APPLICATION NO.	FILING DATE	FIRST NAMED INVENTOR	ATTORNEY DOCKET NO.	CONFIRMATION NO.
10/797,586	03/09/2004	Shyam Kapur	7346-54US	4711
29858	7590	08/23/2006	EXAMINER	
BROWN, RAYSMAN, MILLSTEIN, FELDER & STEINER LLP 900 THIRD AVENUE NEW YORK, NY 10022			LEWIS, CHERYL RENE A	
			ART UNIT	PAPER NUMBER
			2167

Office Action Summary	Application No. 10/797,586	Applicant(s) KAPUR ET AL.	
	Examiner Cheryl Lewis	Art Unit 2167

DETAILED ACTION

FIG. 8A

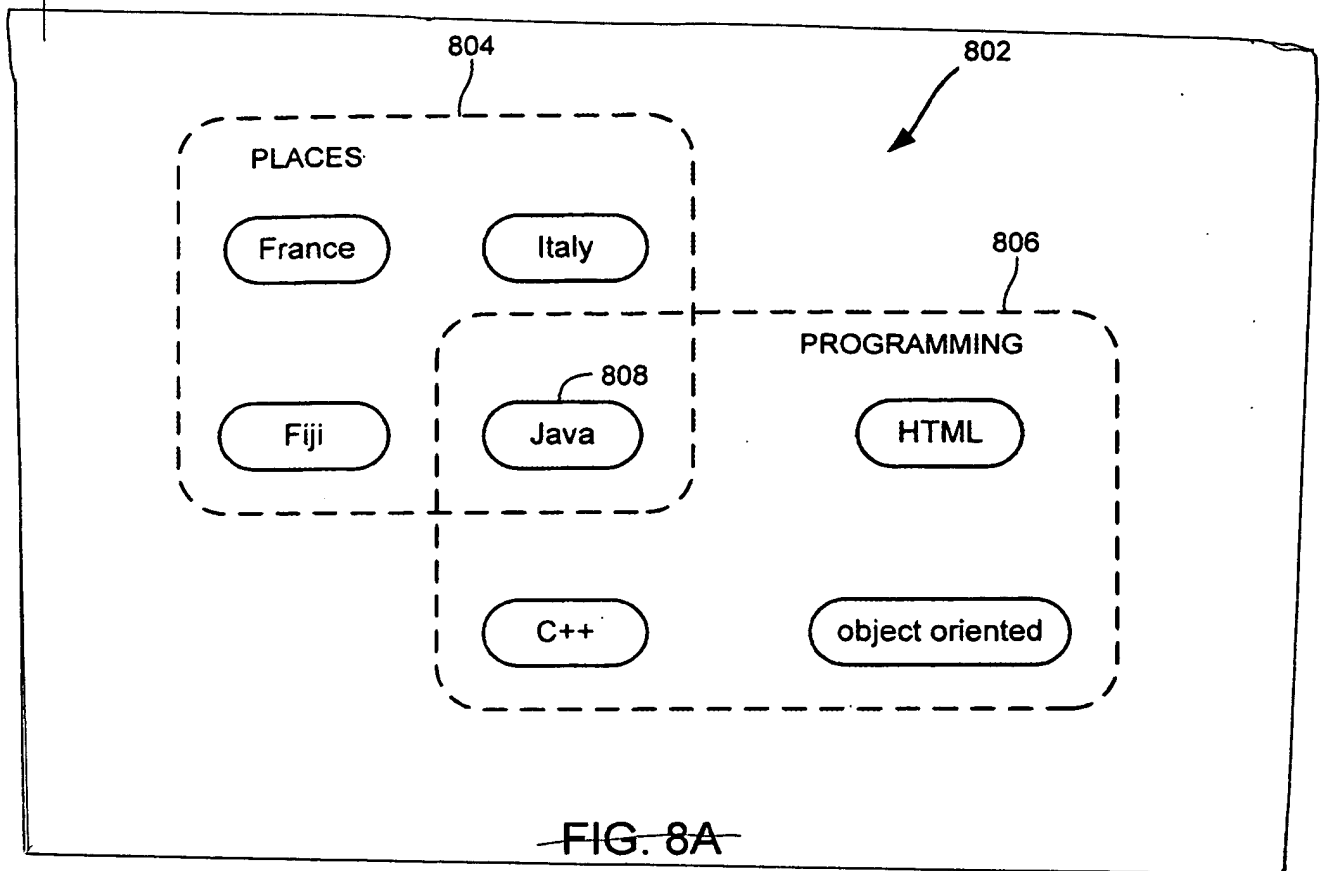
6. The drawings are objected to because drawing figures 8A-10 and 11B-12 depict a partial view of the drawing figures. A box and/or a line drawn around each individual

drawing figure is needed to show each individual figure as a separate entity (MPEP 37 CFR 1.84(h)).

As a convenience to the applicants, the examiner has attached an amendment of drawing figures 8A-10 and 11B-12 to show by example, how to effectively amend drawing figures 8A-10 and 11B-12.
